Number	Description
1	Revised or Added Plan Sheet Nos. 8001, 8016, 8037, 8069, 8070, & 8071; Amendment EBS Download Required.

BR-0018-02(052) / 103325301

Attala County(ies)

ADDENDUM

3/3/14	DATE	REVISED POURING SEQUENCE NOTE	MRA	BY	MISSISSIPPI DEPARTMENT OF TRANSPORTATION BRIDGE AT STA. 438+37.21	
					SPAN NOS. 1 & 2 DETAILS	
					PROJECT 103325/301000 BR-0018-02(052)	WORKING NUMBER B12 of 21
					ATTALA COUNTY	SHEET NUMBER 8037

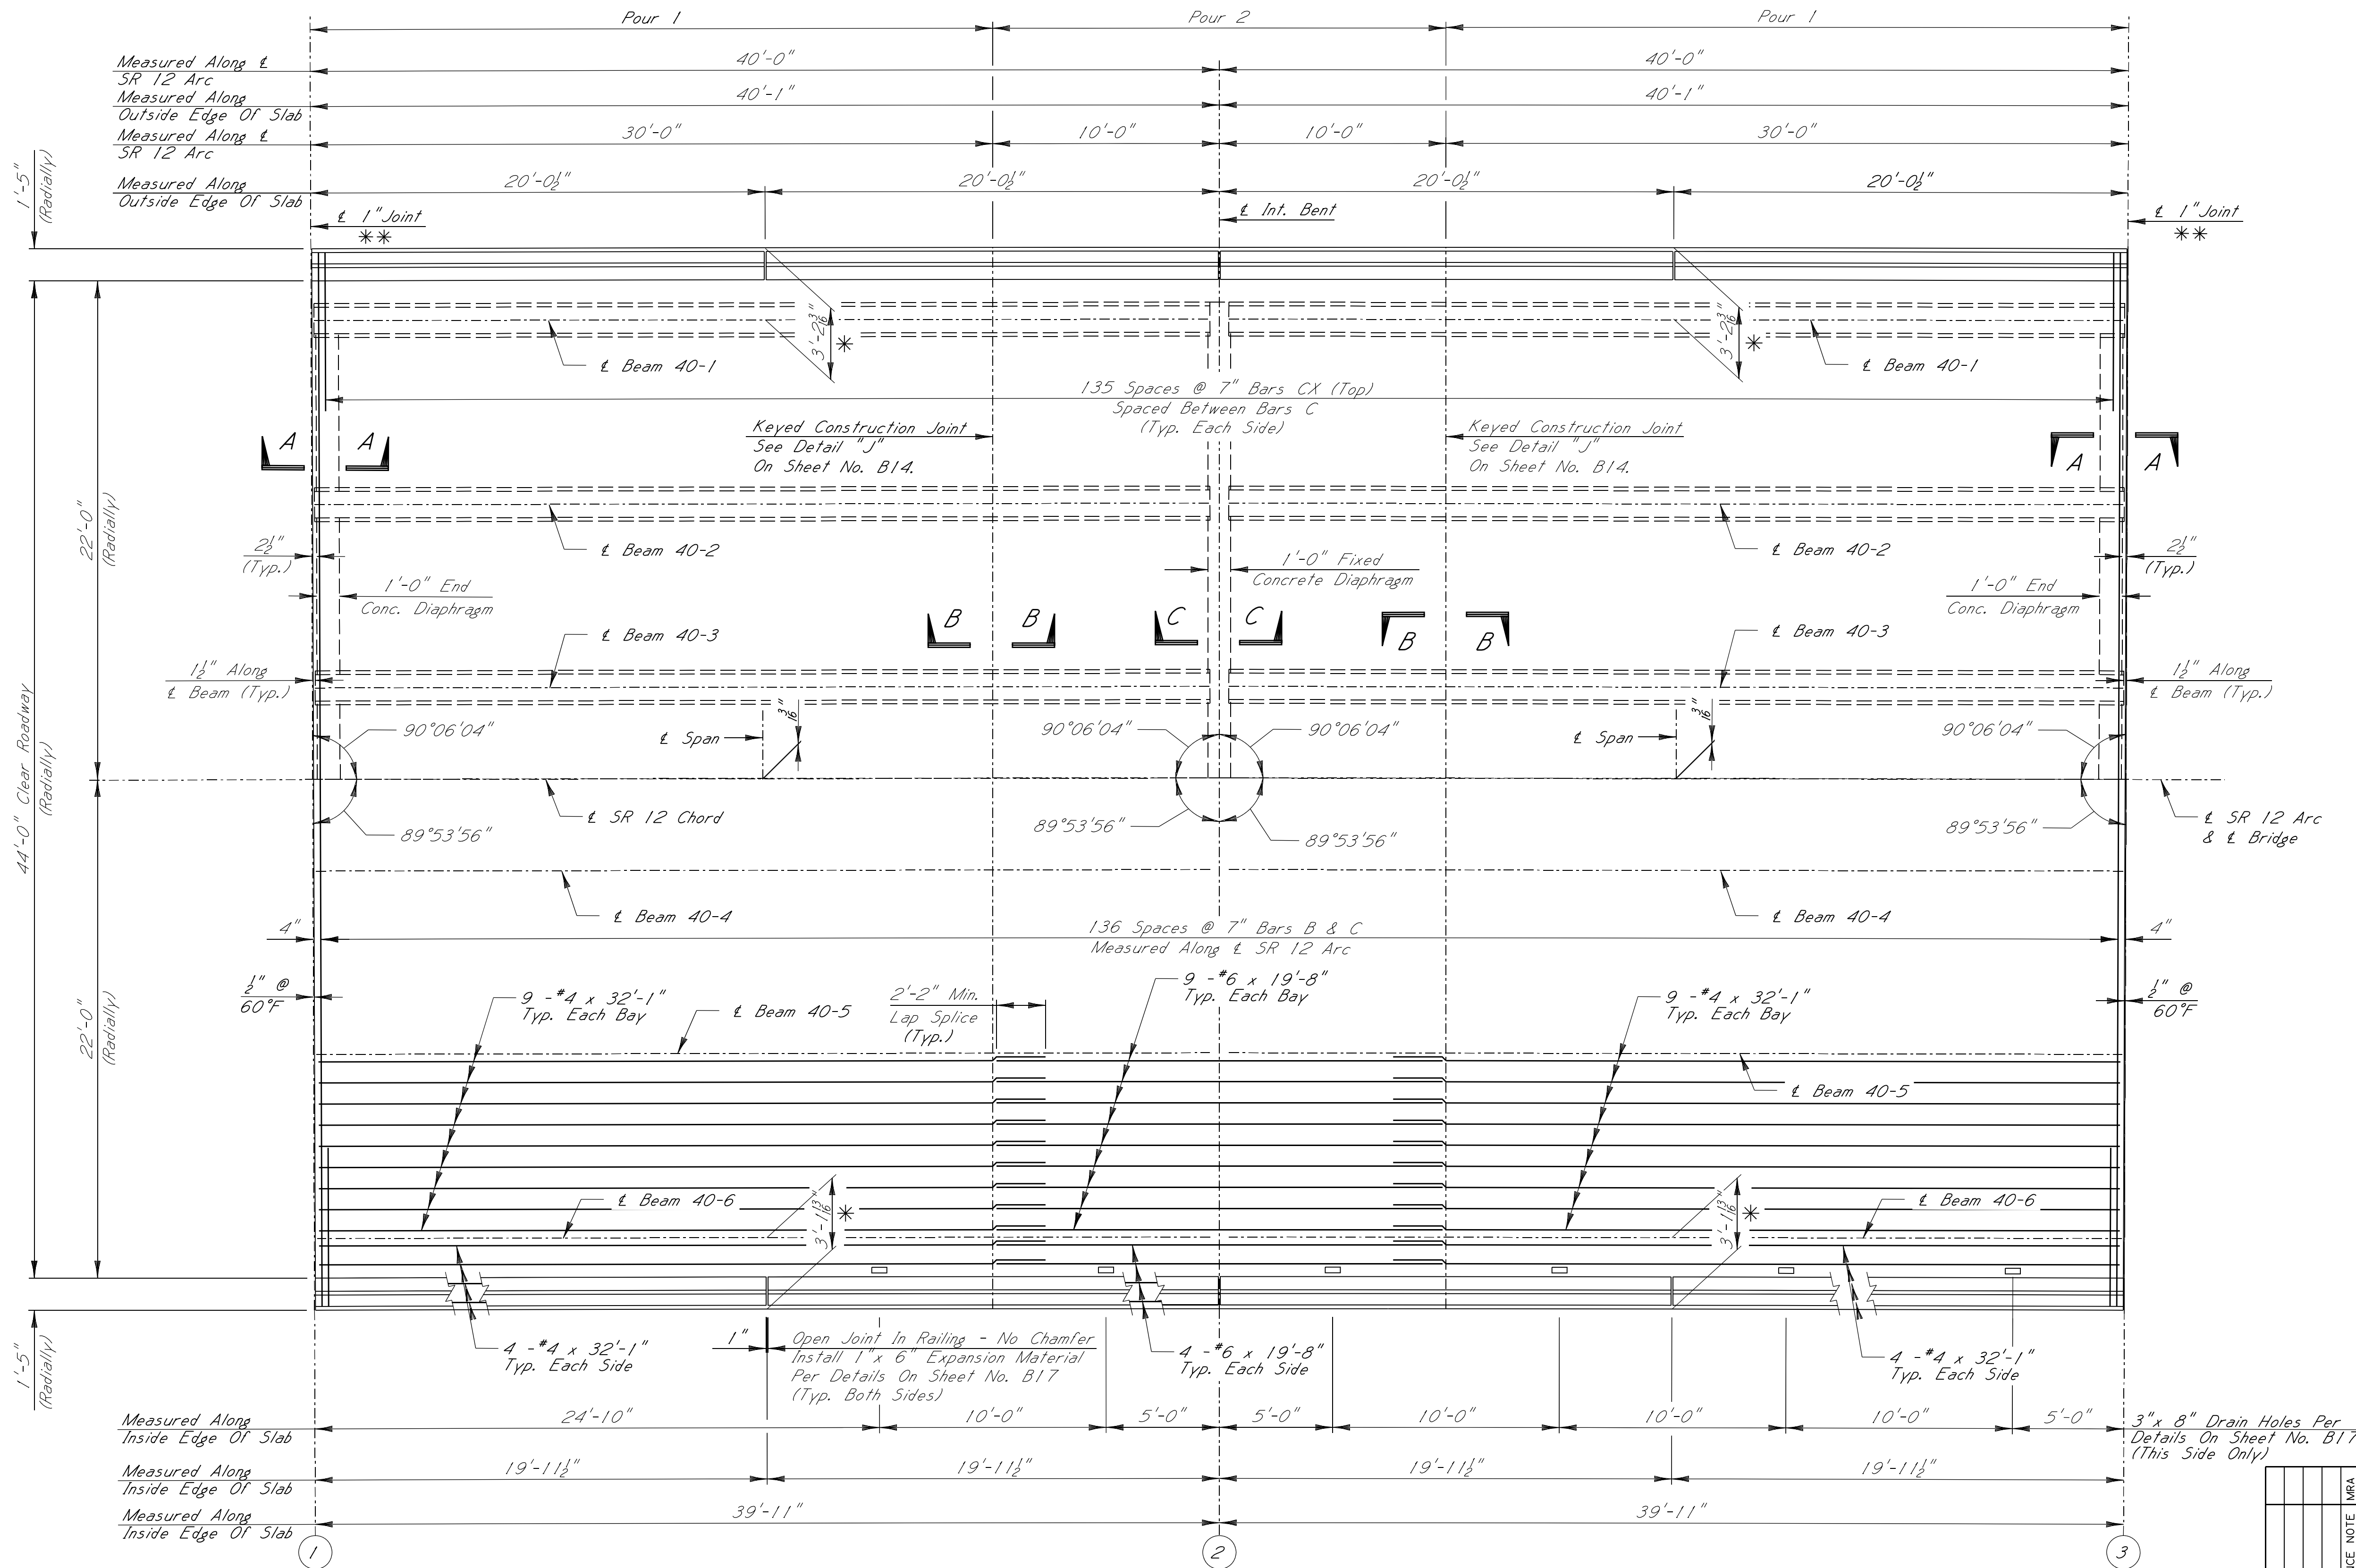
NOTE:
The Deck Pouring Schedule As Shown On These Plans Is Recommended And Shall Be Used Unless An Alternate Pouring Sequence Is Submitted And Approved By The Director Of Structures, State Bridge Engineer.

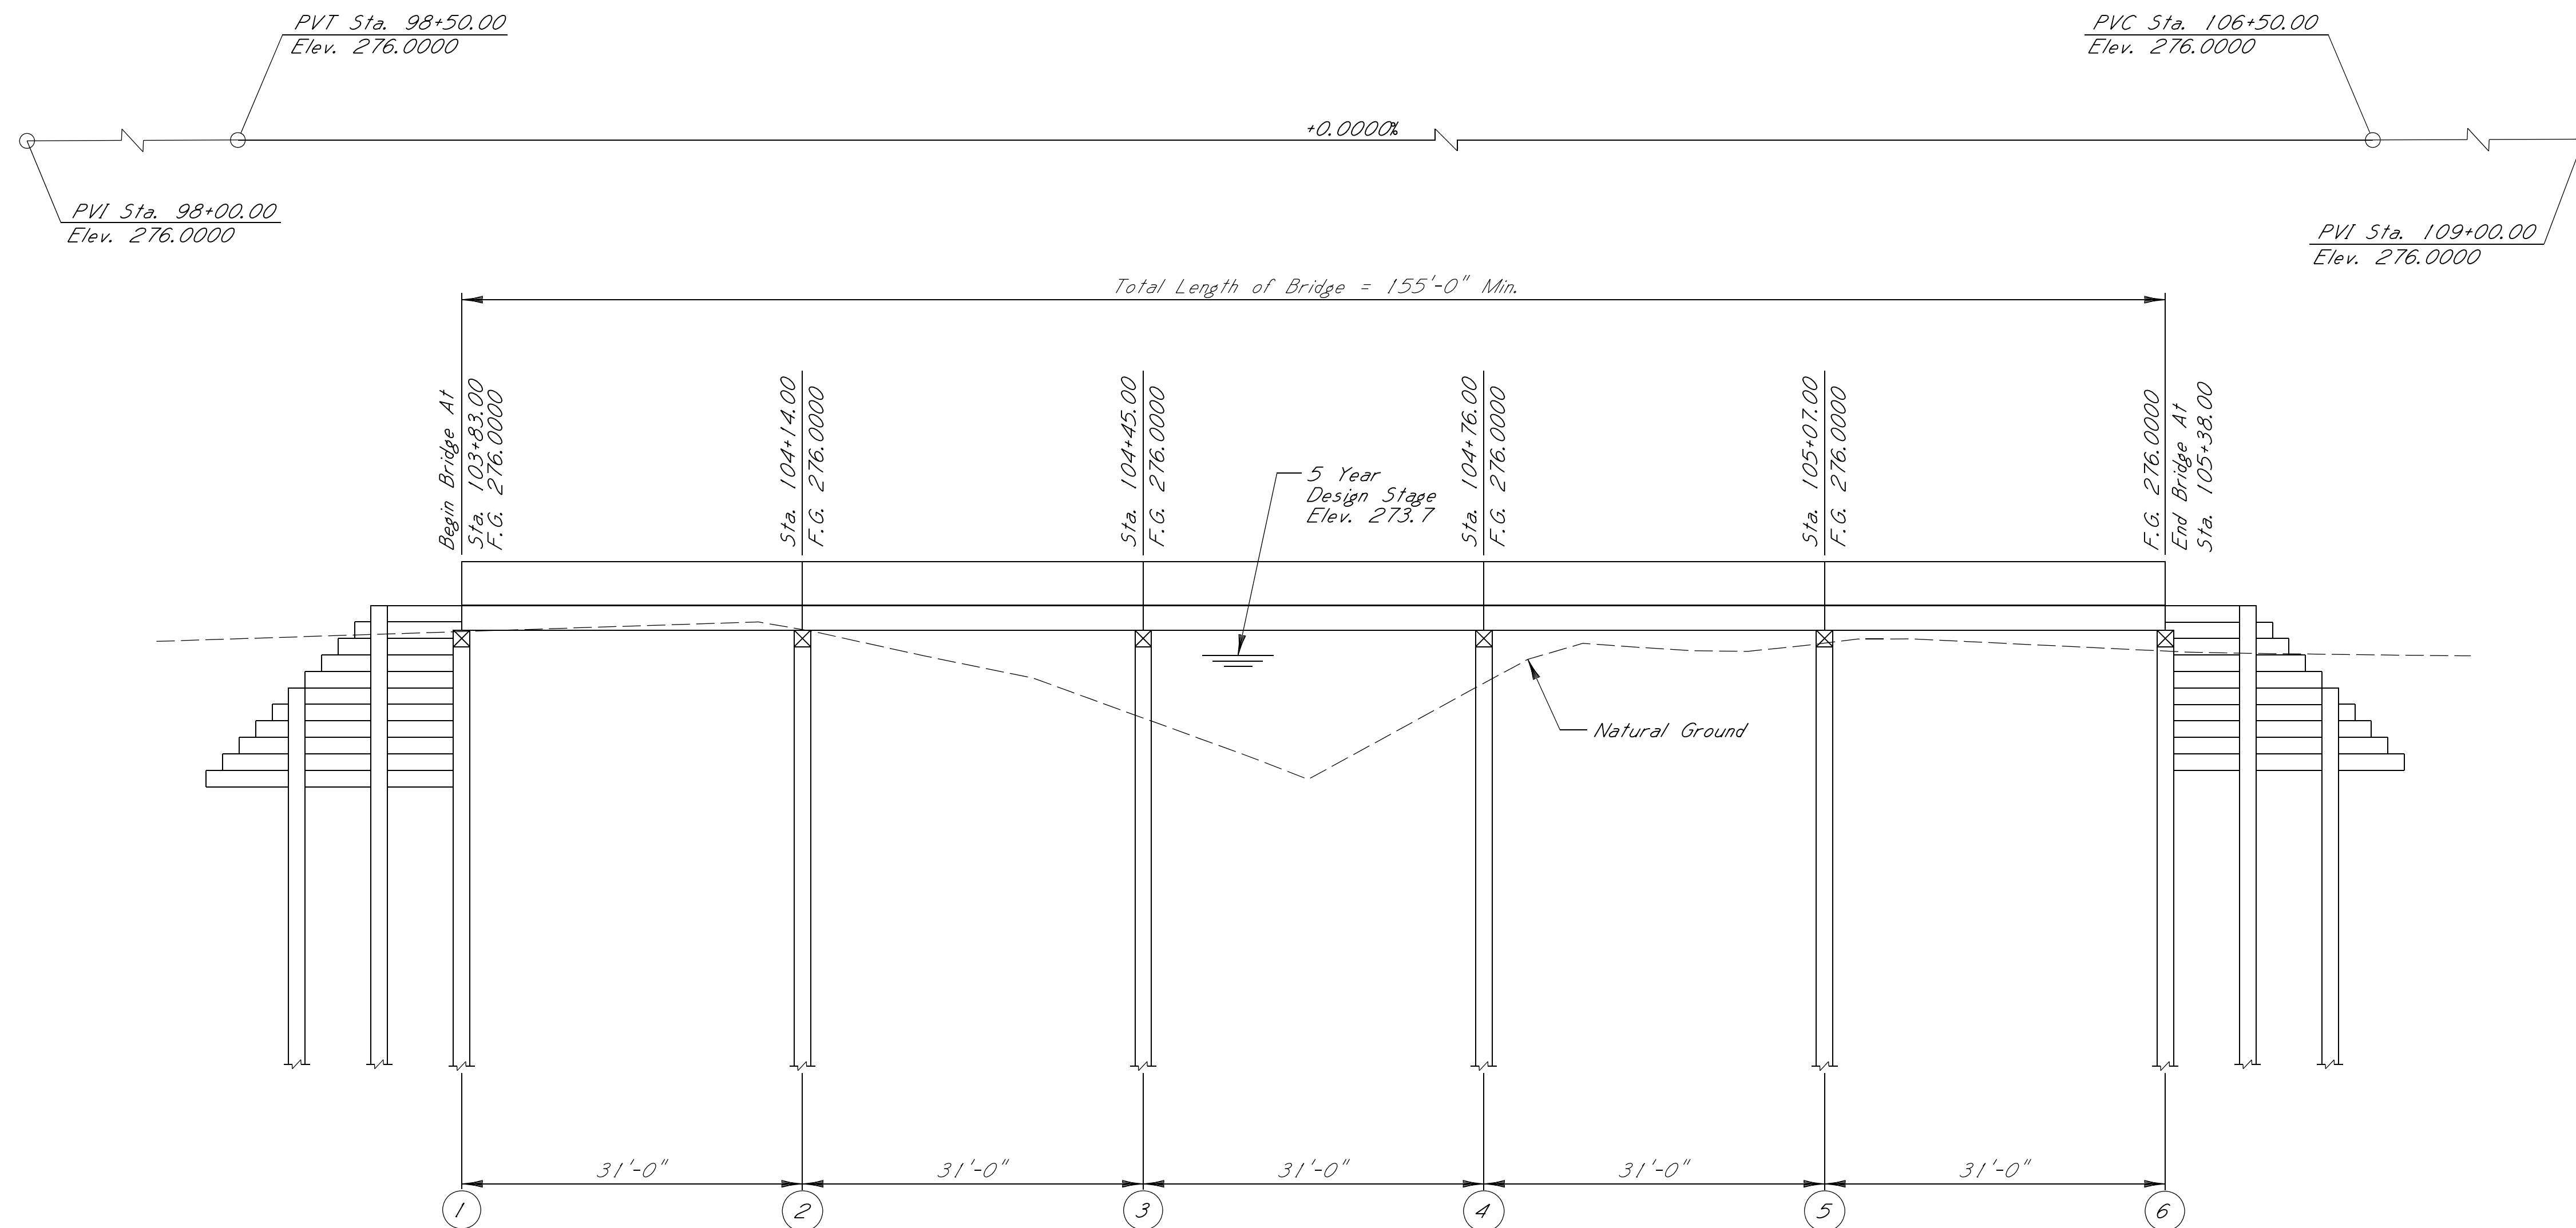
NOTE TO CONTRACTOR:

The Contractor shall employ the service of a registered Professional Engineer who is knowledgeable and proficient in the field of bridge design.

The Contractor's Design Engineer shall determine the required ultimate pile bearing capacities based on the use of Pile Dynamic Analysis (PDA) for the condition/bearing resistance determination method per the AASHTO LRFD Bridge Design Specifications.

The Contractor's Design Engineer will be responsible for providing the Pile Dynamic Analysis (PDA) and for establishing the production pile driving criteria.

The Contractor's Design Engineer shall determine the lengths of all test piles and production piles.

The following exceptions to the AASHTO LRFD Bridge Design Specifications will be allowed for the design of Detour Bridges:

- (1) The design of the substructure of the Detour Bridge shall be made to satisfy the requirements of the following Limit States: Strength I, Strength III, Strength V, and Service I.
- (2) With PDA pile tests for the Detour Bridge Piling being performed and analyzed by the Contractor's Design Engineer, a value of 0.85 for the condition/resistance Factor for Driven Piles may be used to set final Detour Bridge pile lengths.
- (3) The Design Vehicular Loading (Truck + Lane) used may be 75% of the HL-93 Live Loading.

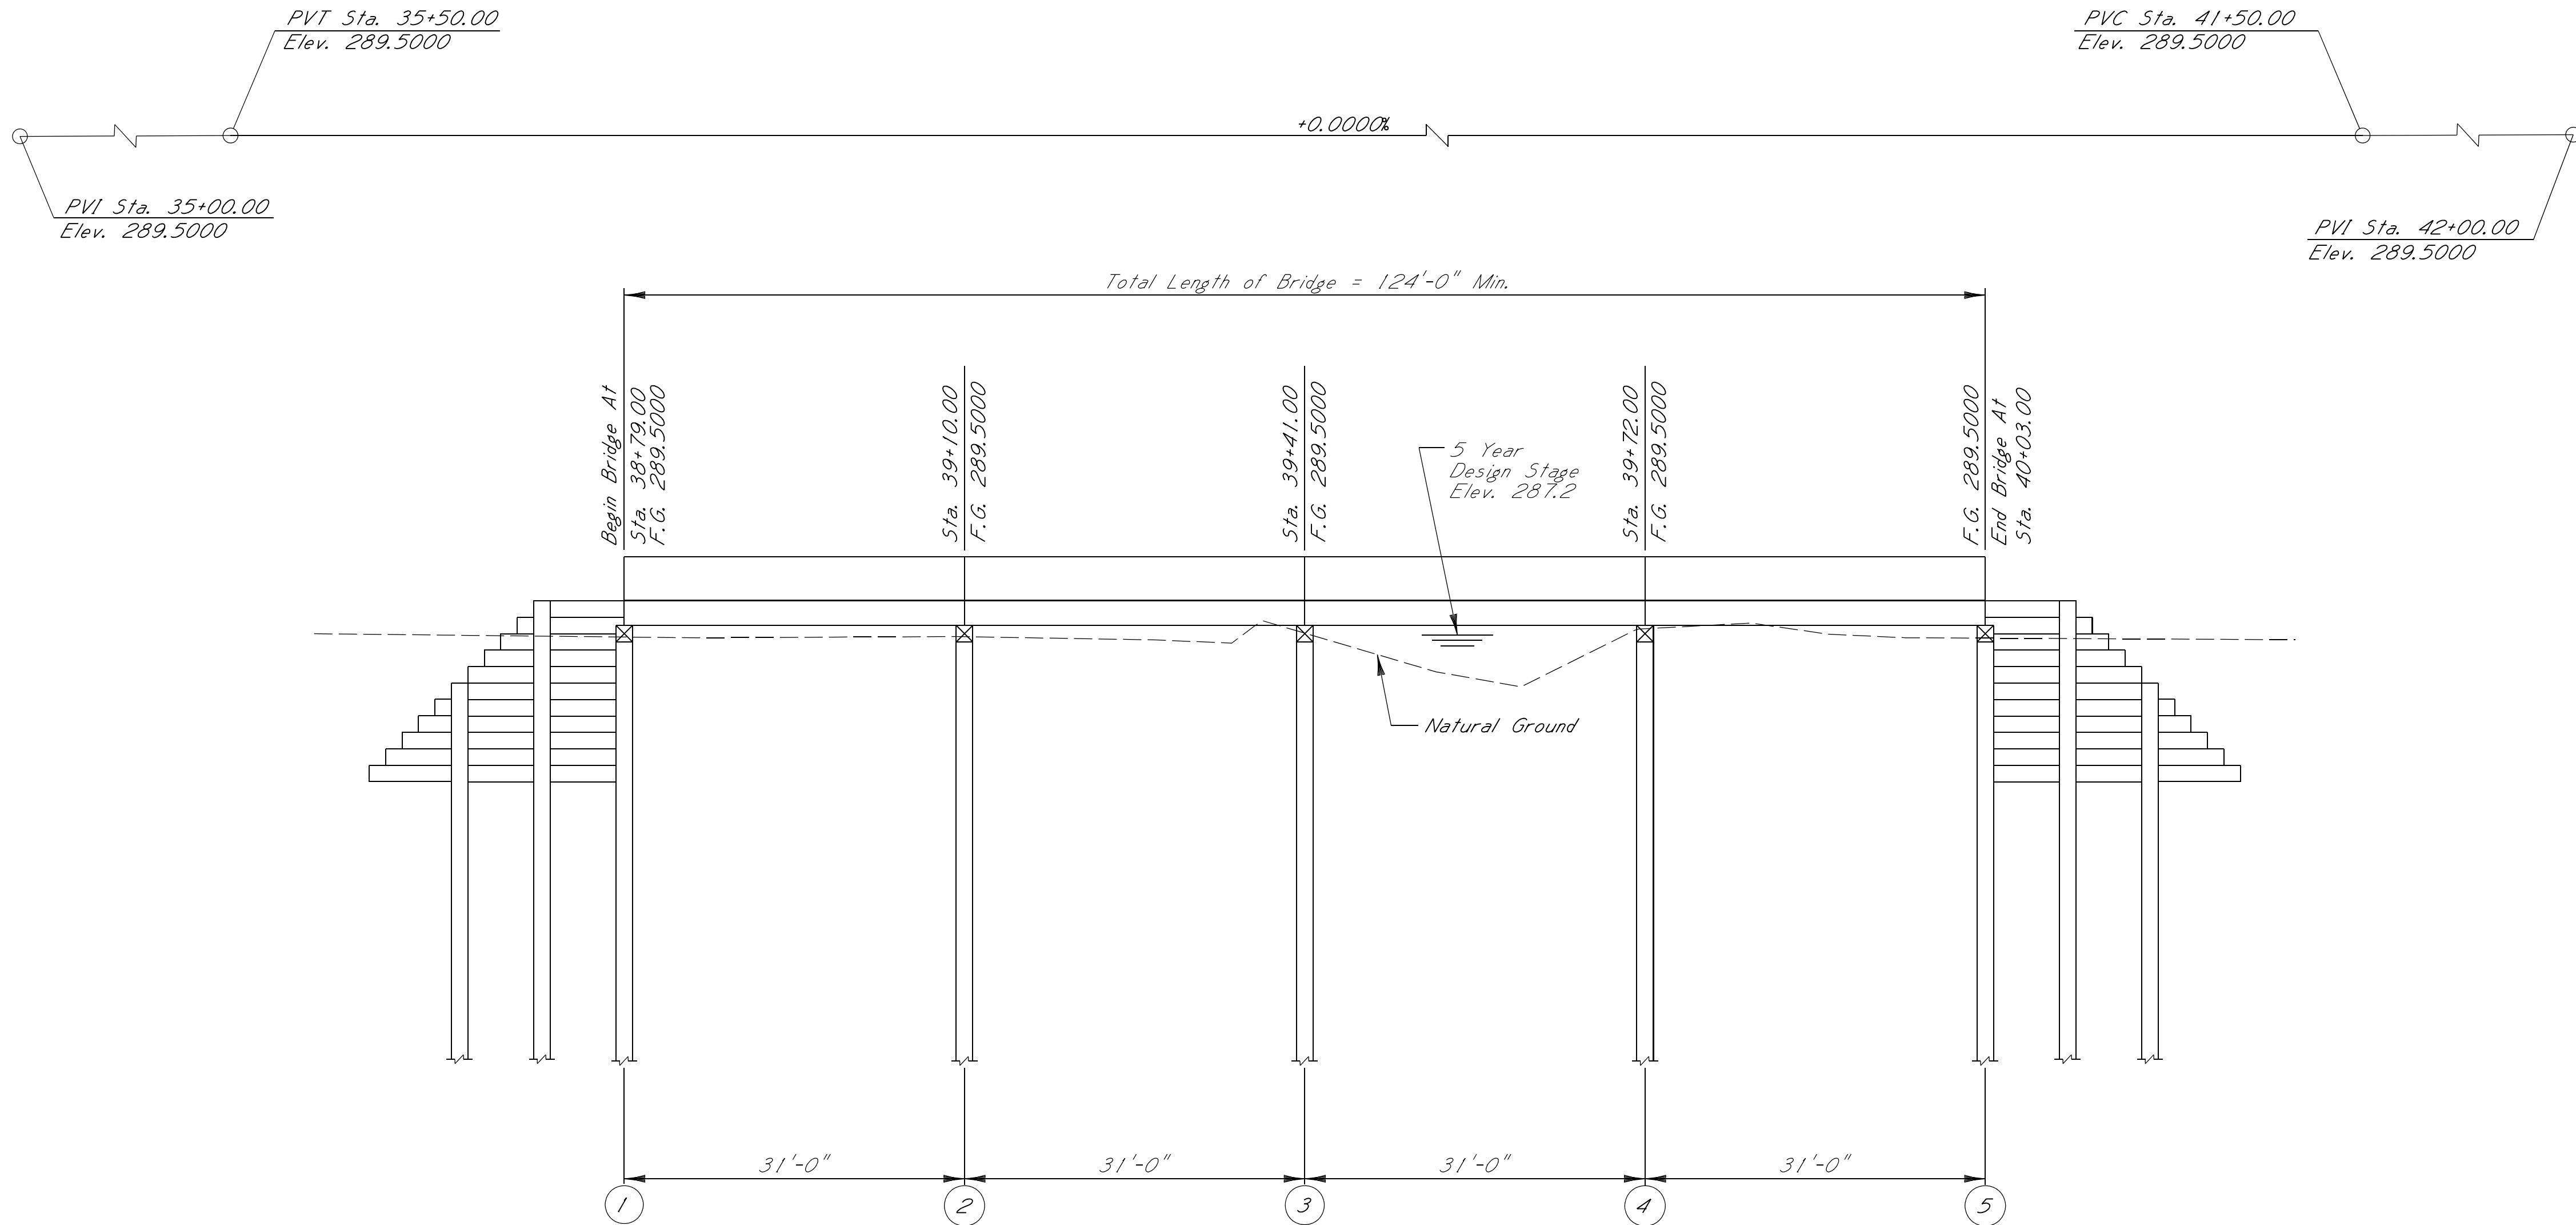
NOTE TO CONTRACTOR:

The Contractor shall employ the service of a registered Professional Engineer who is knowledgeable and proficient in the field of bridge design.

The Contractor's Design Engineer shall determine the required ultimate pile bearing capacities based on the use of Pile Dynamic Analysis (PDA) for the condition/bearing resistance determination method per the AASHTO LRFD Bridge Design Specifications.

The Contractor's Design Engineer will be responsible for providing the Pile Dynamic Analysis (PDA) and for establishing the production pile driving criteria.

The Contractor's Design Engineer shall determine the lengths of all test piles and production piles.

The following exceptions to the AASHTO LRFD Bridge Design Specifications will be allowed for the design of Detour Bridges:

- (1) The design of the substructure of the Detour Bridge shall be made to satisfy the requirements of the following Limit States: Strength I, Strength III, Strength V, and Service I.
- (2) With PDA pile tests for the Detour Bridge Piling being performed and analyzed by the Contractor's Design Engineer, a value of 0.85 for the condition/resistance Factor for Driven Piles may be used to set final Detour Bridge pile lengths.
- (3) The Design Vehicular Loading (Truck + Lane) used may be 75% of the HL-93 Live Loading.
